June 4, 2019

**RE: Reinitiation of Consultation on Long Term Operations of the State Water Project and Central Valley Project**

*June 4, 2019 Letter to National Marine Fisheries Service regarding Biological Assessment for Reinitiation of Consultation on Long Term Operations of the CVP and SWP*

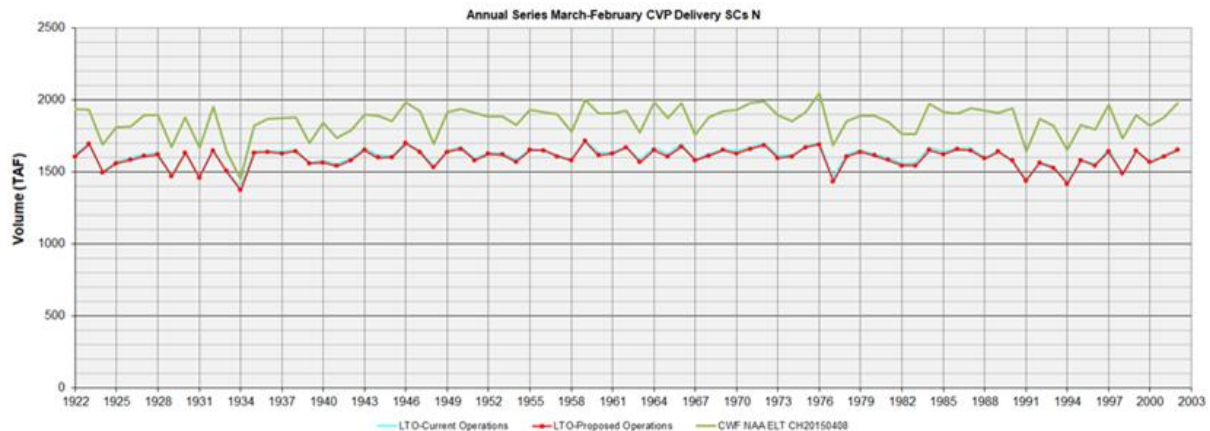
Unlike prior consultations and environmental reviews, this biological assessment only models the effects of recent historic levels of water diversions by Sacramento River Settlement Contractors instead of full contract amounts. The modeling assumptions in the BA explicitly states that the CalSim modeling only analyzes historic diversions by the Sacramento River Settlement Contractors, not the full contract amounts. *Id.*, Appendix D at 46 (“Land-use based, full buildout of contract amounts, except for Settlement Contractors represented with historical diversions.”); *id.* at 47.<sup>5</sup>

CalSim results from the BA also demonstrate that the Bureau of Reclamation changed the assumptions regarding the amount of water diversions by Sacramento River Settlement Contractors in both the Continued Operations Scenario and the Proposed Project. In recent previous ESA consultations and NEPA analyses the Bureau of Reclamation analyzed the effects of full contract amounts by the Sacramento River Settlement Contractors, including the California WaterFix biological opinions, California WaterFix Final EIS/EIR, and the 2015 Final EIS on Long Term Operations of the CVP and SWP. In contrast, here the Bureau of Reclamation has significantly reduced water diversions by Sacramento River Settlement Contractors in the model, limiting those diversions to historic levels rather than full contract

amounts. Staff from the U.S. Fish and Wildlife Service confirmed that the CalSim model results show a significant reduction in water diversions by Sacramento River Settlement Contractors as compared to the California WaterFix modeling, providing the graphic below, and that this was a result of changes in the assumptions. See Email from Derek Hilts to Doug Obegi dated March 28, 2019.

The Sacramento River Settlement Contractors have never diverted their full contract amounts, and in most years total diversions are only 75% or less of full contract amounts. As a result, this change in modeling assumption significantly altered the modeling results, including causing a significant increase in carryover storage in Shasta Reservoir as compared to those earlier modelling efforts.
